VIRGINIA ELECTRIC AND POWER COMPANY
SURRY POWER STATION UNITS 1 AND 2
ASME SECTION XI INSERVICE INSPECTION PROGRAM
REQUESTS FOR RELIEF CMP-001 REVISION 1

**Relief Request CMP-001 Revision 1
Surry Unit 1**

**Relief Request CMP-001 Revision 1
Surry Unit 2**

Response to Previous NRC Requests for Additional Information
Relief Requests CMP-001

FIGURE 1

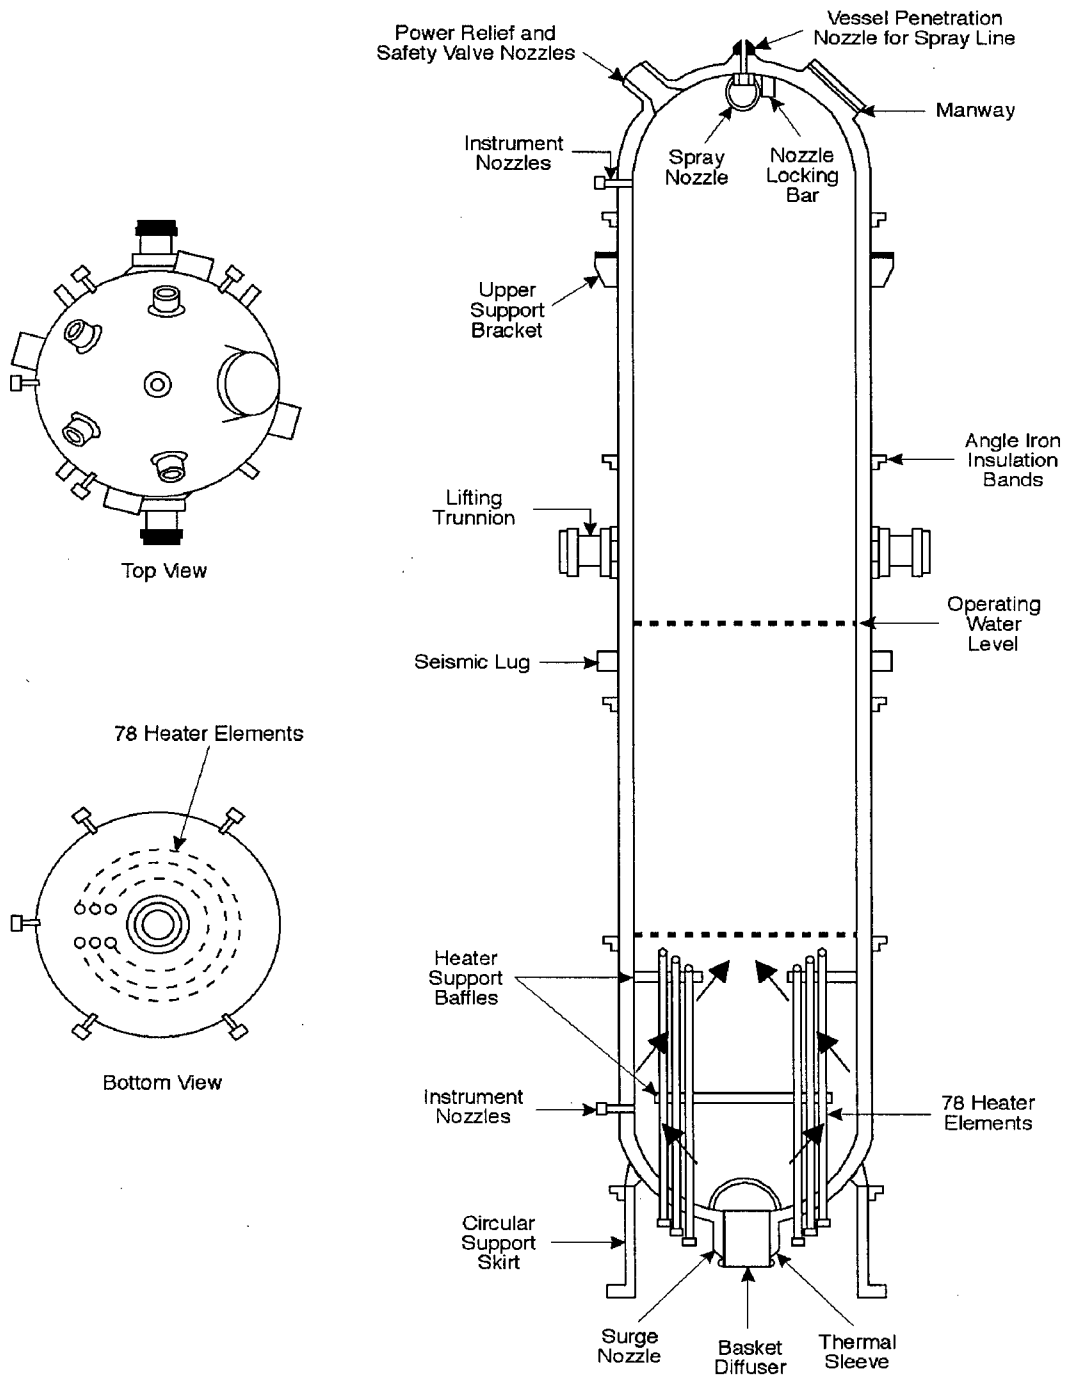
The Surry Unit 1 pressurizer surge line nozzle is integrally cast into the bottom head of the pressurizer. The nozzle is located under the pressurizer skirt and is surrounded by the 78 heater penetrations (Figure 1). Multi-layered, stainless steel mirror insulation and cables for the pressurizer heaters (Figure 2) obstruct access to the nozzle.

HEATER ELEMENTS/LAYERED INSULATION FIGURE 2

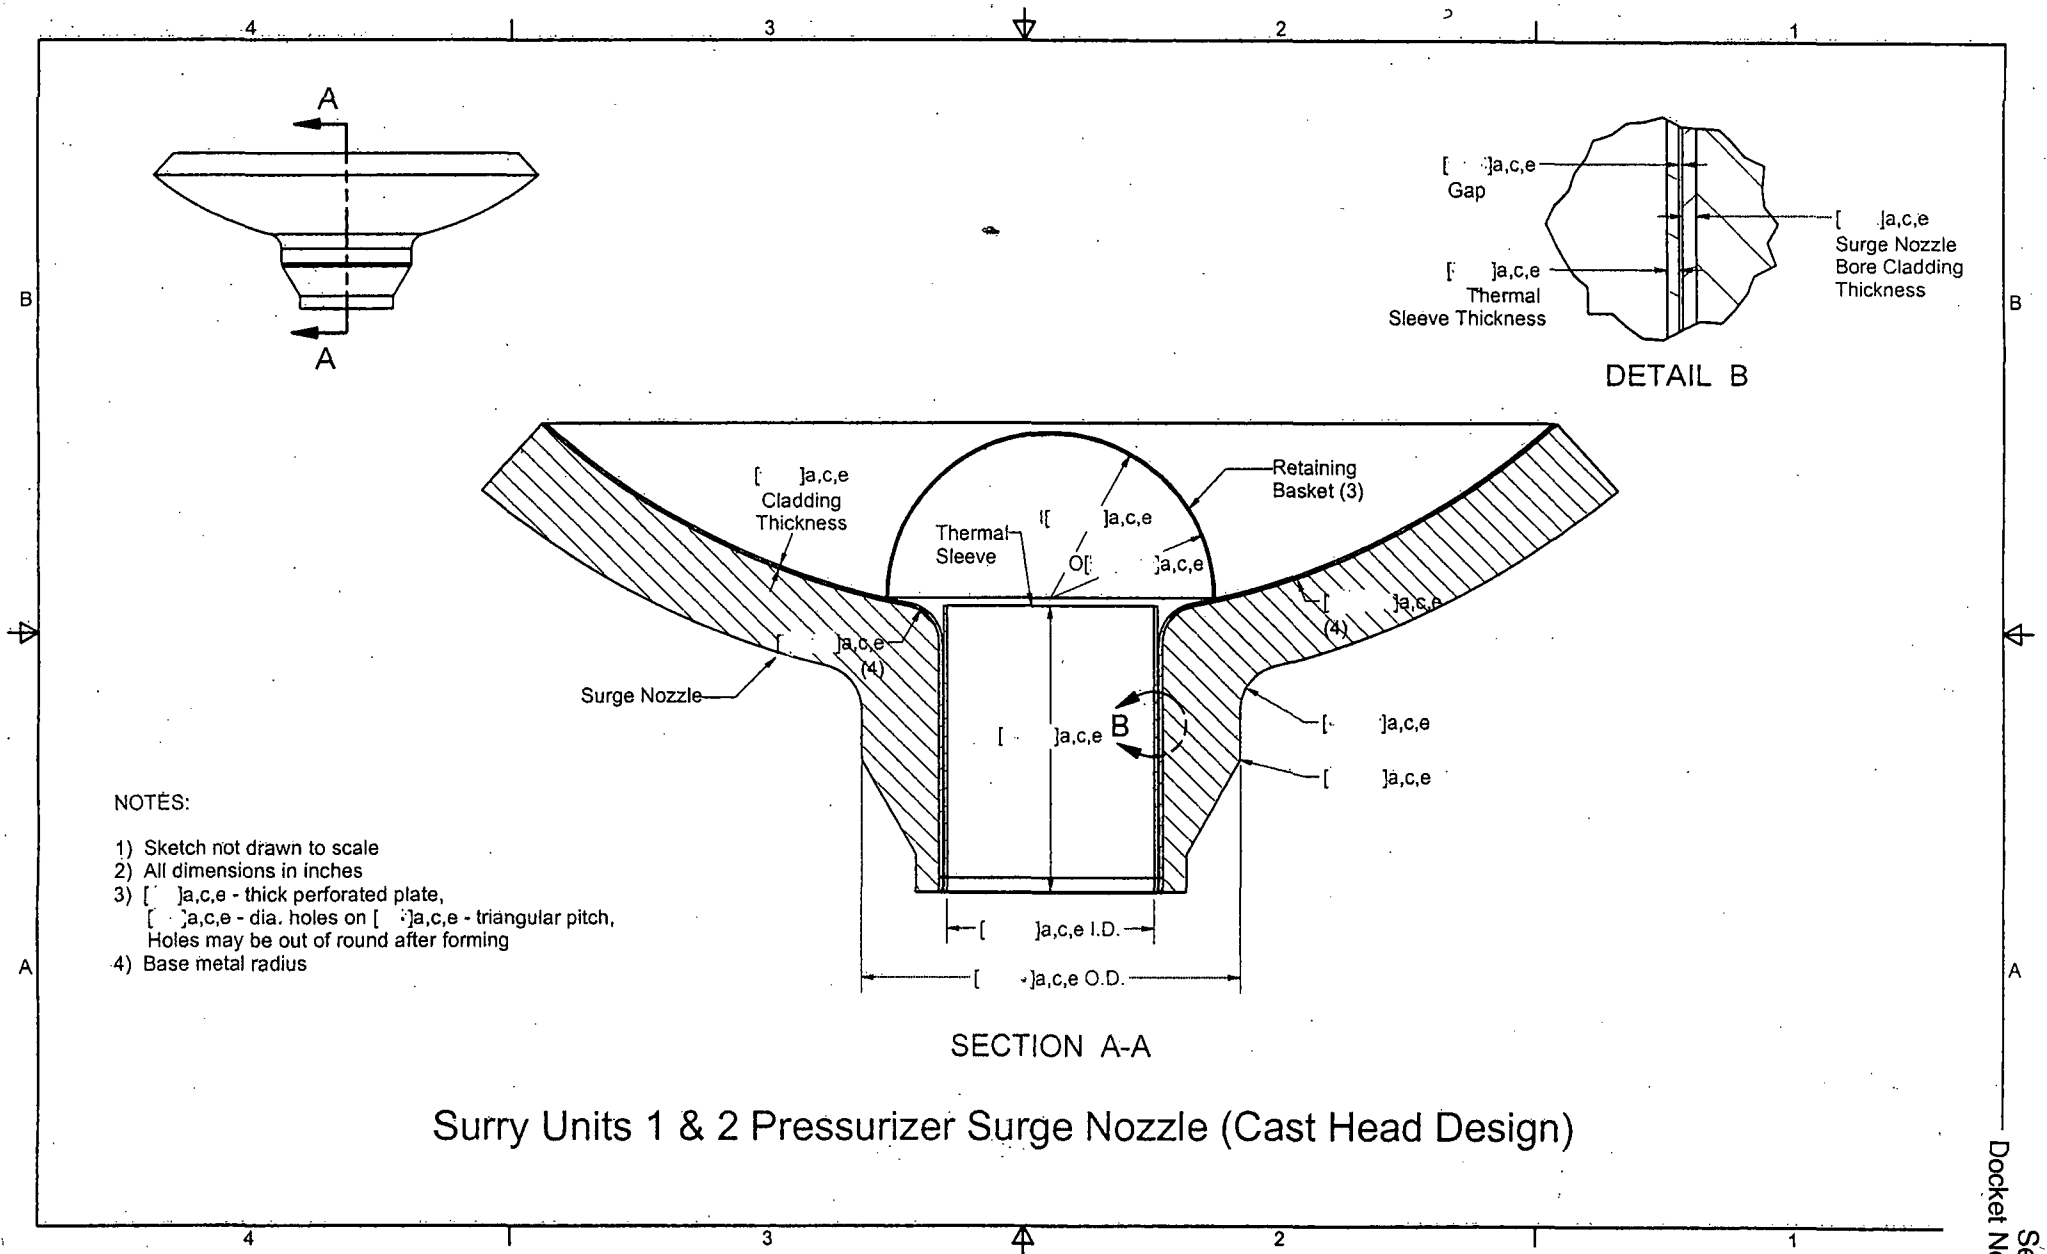
Question - "The licensee states that any ultrasonic examination of the pressurizer surge nozzle could only be described as "best effort". The licensee also states that remote visual technology has very little if any reasonable probability of success. The licensee made similar statements when requesting the same relief on the pressurizer surge nozzle for the third 10-year ISI interval. Given that ultrasonic testing examination techniques and technology as well as remote visual technology has improved greatly in the last 10 years, please explain what steps have been taken by the licensee in the past 10 years to try to improve the level of inspection on the pressurizer surge nozzle. The staff also requests detailed drawings that show cross sectional view of the surge nozzle, thermal sleeve, basket diffuser and material specification, as well as drawings that clearly show interference on the outside of the vessel. The drawings should include dimensions."

Question - "VEPCO stated that any ultrasonic examination of the pressurizer surge nozzle could only be described as "best effort," and that a remote visual examination, conducted from the inside of the pressurizer, has very little probability of success. Similar statements were made when requesting the same relief during previous inspection intervals. Given that advancements in ultrasonic testing and remote visual technologies have been made since the previous request, describe what steps have been taken by the licensee to improve the level of inspection for the pressurizer surge nozzle. In addition, provide detailed drawings that show cross-sectional views of the surge nozzle, thermal sleeve, and basket diffuser. The staff requests that these

- A) The distance from the centerline of the innermost immersion heater to the edge of the surge nozzle is []^{a,c,e}.
- B) The original diameter of holes in the nozzle cover plate (retaining basket in Figure 1) prior to forming from a flat plate is []^{a,c,e}. Some holes may be out of round after the forming process.

- C) Figure 1 is the sketch detailing the inside nozzle radius section distances, and is provided as 'Sketch of Surry Units 1 & 2 Pressurizer Surge Nozzle (Cast Head Design)'.

Based on the design inputs to create the sketch (Figure 1) in this document, unless the retaining basket was modified, or removed prior to installation in the pressurizer, it is Westinghouse's judgment that a remote visual examination of the surge nozzle inside radius surface would be extremely difficult to perform. The probe would have to be placed into the pressurizer through the manway access in the top of the pressurizer, and then lowered approximately []^{a,c,e}, with a transmission and power cable for a portable light source in tow, through the cut-outs of the two baffle plates, and then through a []^{a,c,e} diameter hole in the retaining basket to examine the surge nozzle inside radius. Unless the probe was readily controllable, the probe would have to be reinserted through the retaining basket holes numerous times, to examine the entire surge nozzle inside radius surface. It should also be noted that it is quite possible that the holes in the retaining basket may no longer be []^{a,c,e} in diameter since some holes are most likely out of round due to the retaining basket forming process, further complicating the visual inspection of the surge nozzle inside radius surface.

Response - Figure 3 in the relief requests included in Attachments 1 and 2 has been added to provide a detailed drawing of the surge line nozzle. Dimensions for the drawing are provided in the proprietary version included in Attachment 5. The lower pressurizer head and nozzle material is SA-216 Grade WCC cast carbon steel.

Response - Figure 3 in the relief requests has been added to provide detailed drawings of the surge line nozzle. Dimensions for the drawing are provided in the proprietary version included in Attachment 5. The lower pressurizer head and nozzle material is SA-216 Grade WCC cast carbon steel.

FIGURE 1

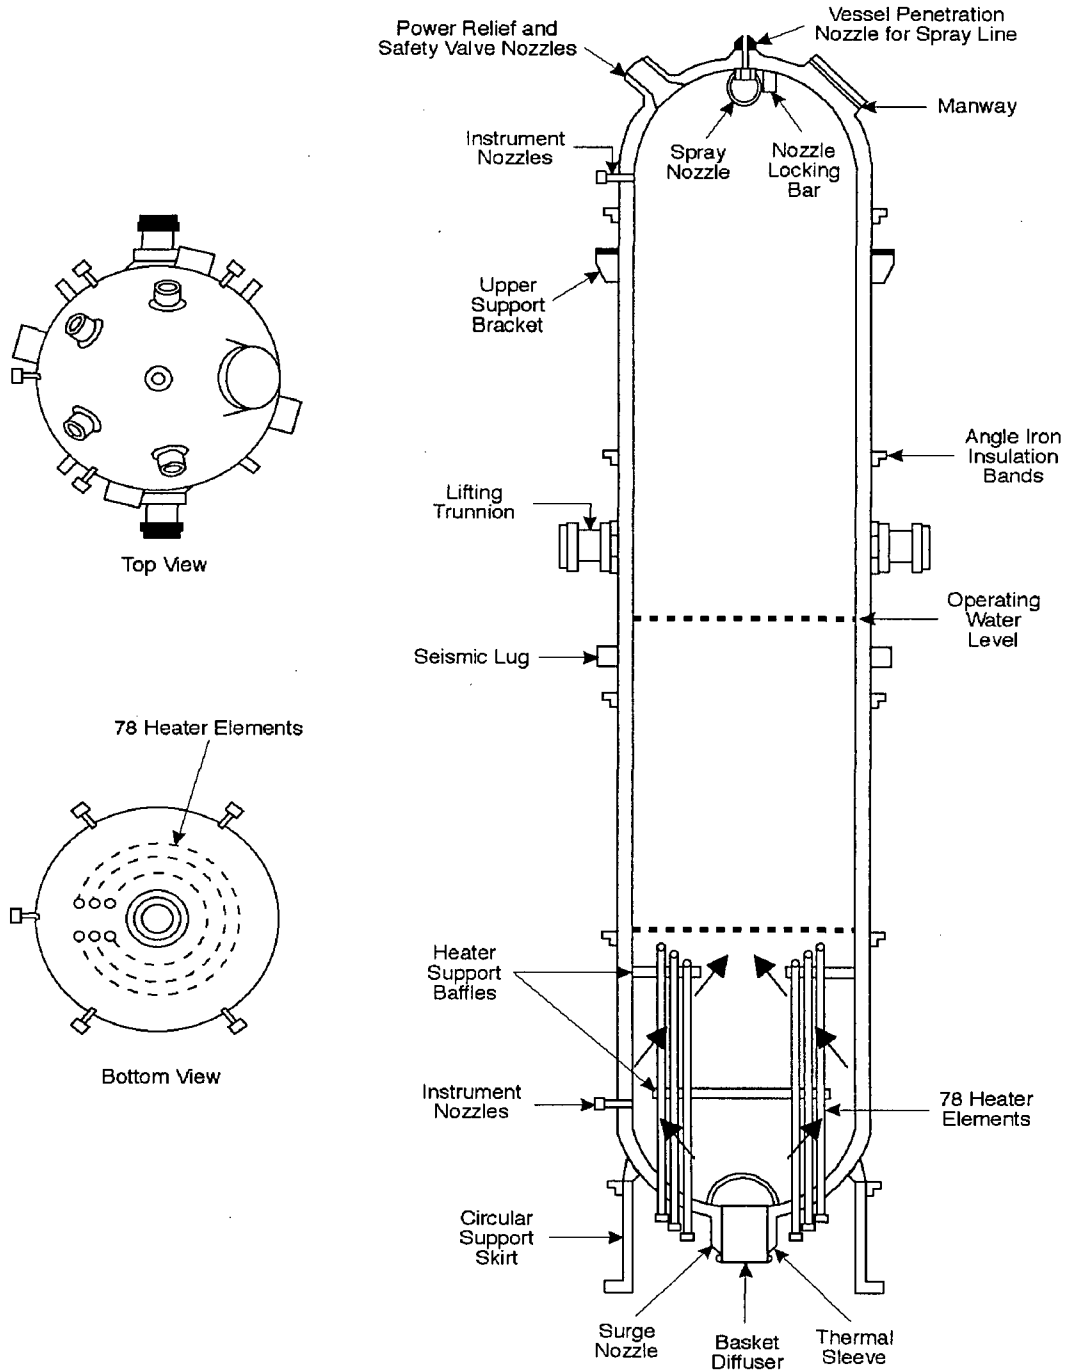
The Surry Unit 2 pressurizer surge line nozzle is integrally cast into the bottom head of the pressurizer. The nozzle is located under the pressurizer skirt and is surrounded by the 78 heater penetrations (Figure 1). Multi-layered, stainless steel mirror insulation and cables for the pressurizer heaters (Figure 2) obstruct access to the nozzle.

HEATER ELEMENTS/LAYERED INSULATION FIGURE 2

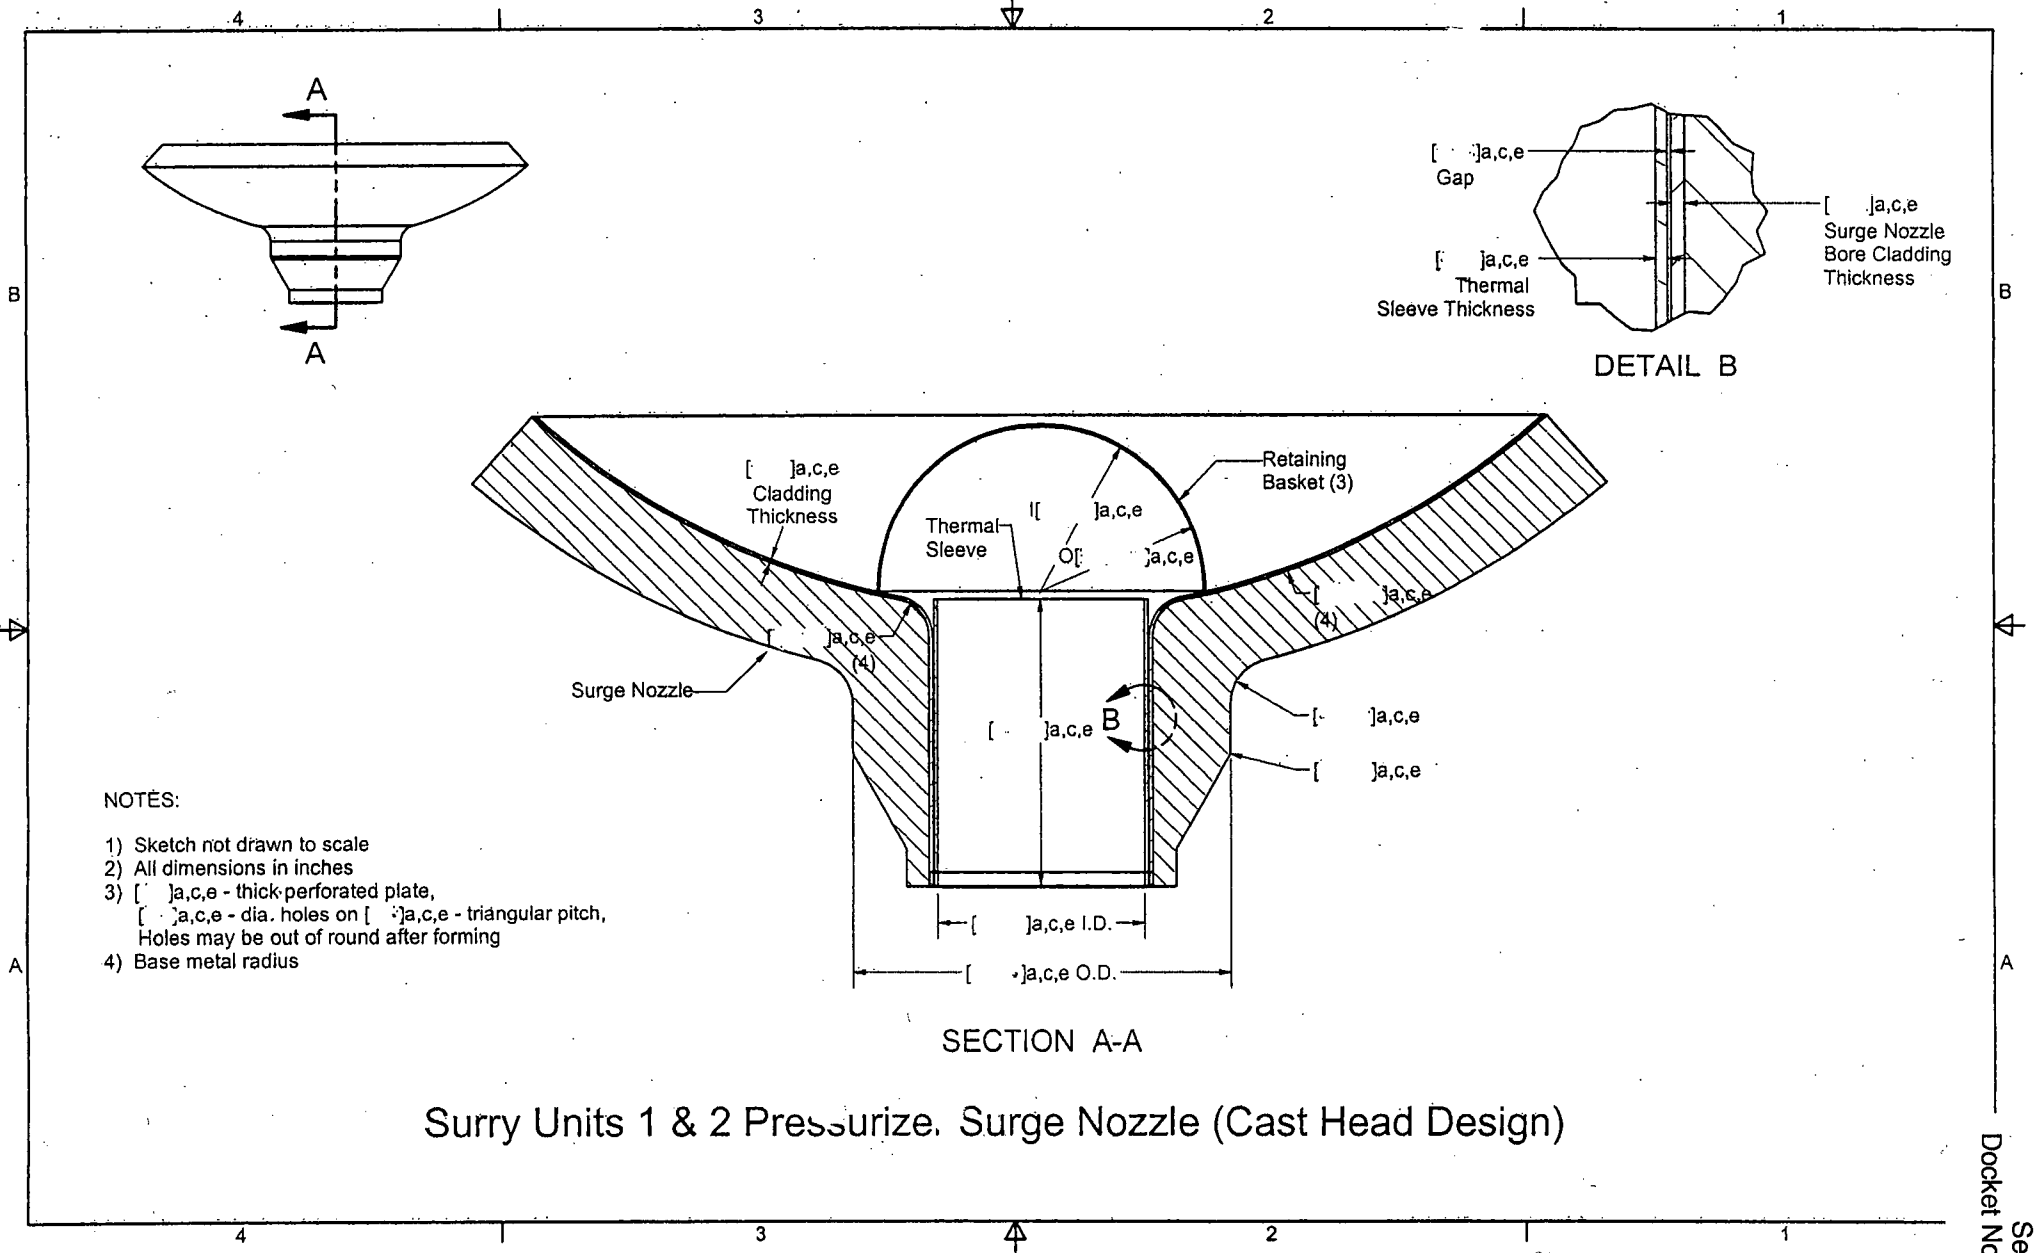
drawings include a list of the material specifications, dimensions of the components, and clearly indicate the interferences on the outside of the vessel for performing ultrasonic examination."

- A) The distance from the centerline of the innermost immersion heater to the edge of the surge nozzle is []^{a,c,e}.
- B) The original diameter of holes in the nozzle cover plate (retaining basket in Figure 1) prior to forming from a flat plate is []^{a,c,e}. Some holes may be out of round after the forming process.

- C) Figure 1 is the sketch detailing the inside nozzle radius section distances, and is provided as 'Sketch of Surry Units 1 & 2 Pressurizer Surge Nozzle (Cast Head Design)'.

Based on the design inputs to create the sketch (Figure 1) in this document, unless the retaining basket was modified, or removed prior to installation in the pressurizer, it is Westinghouse's judgment that a remote visual examination of the surge nozzle inside radius surface would be extremely difficult to perform. The probe would have to be placed into the pressurizer through the manway access in the top of the pressurizer, and then lowered approximately []^{a,c,e}, with a transmission and power cable for a portable light source in tow, through the cut-outs of the two baffle plates, and then through a []^{a,c,e} diameter hole in the retaining basket to examine the surge nozzle inside radius. Unless the probe was readily controllable, the probe would have to be reinserted through the retaining basket holes numerous times, to examine the entire surge nozzle inside radius surface. It should also be noted that it is quite possible that the holes in the retaining basket may no longer be []^{a,c,e} in diameter since some holes are most likely out of round due to the retaining basket forming process, further complicating the visual inspection of the surge nozzle inside radius surface.
